FCC CLASS II PERMISSIVE CHANGE REQUEST LETTER

RE: FCC Permissive II Change Request for Company: LG Electronics USA FCC ID: BEJX160NYA

EUT Type: Microwave Oven
Model Name: MZ1693GSUL
FCC ID.: BEJX160NYA
Applicant: LG Electronics Inc.

■ Original Buzzer

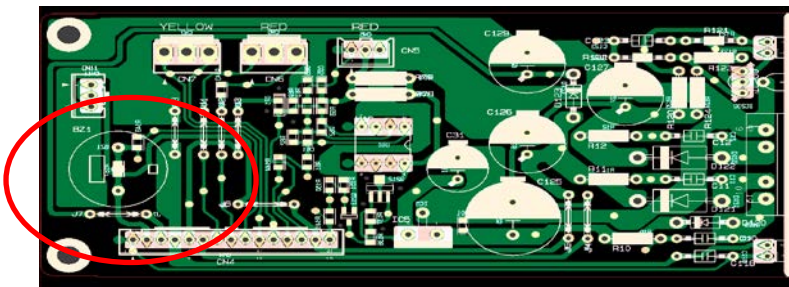
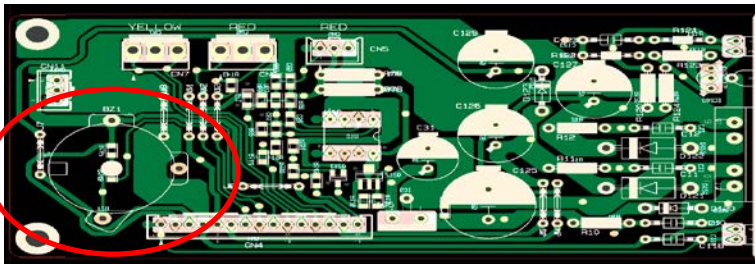
2. Contents of change(s): Buzzer and Noise Filter

■ Alternate Buzzer

■ Original Noise Filter value

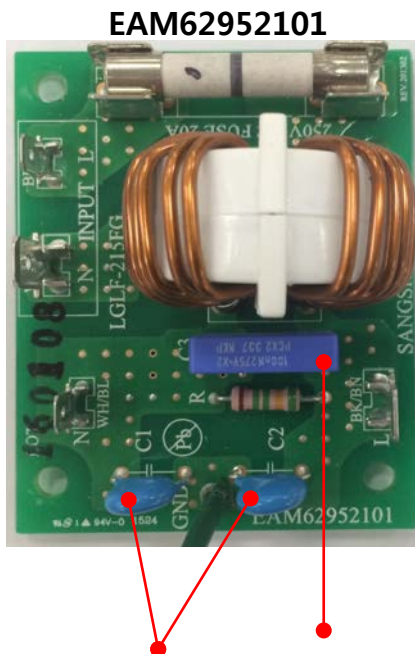
Y Cap : 2200pF X Cap : 0.1uF

■ Alternate Noise Filter value

Y Cap : 1000pF X Cap : 0.33uF
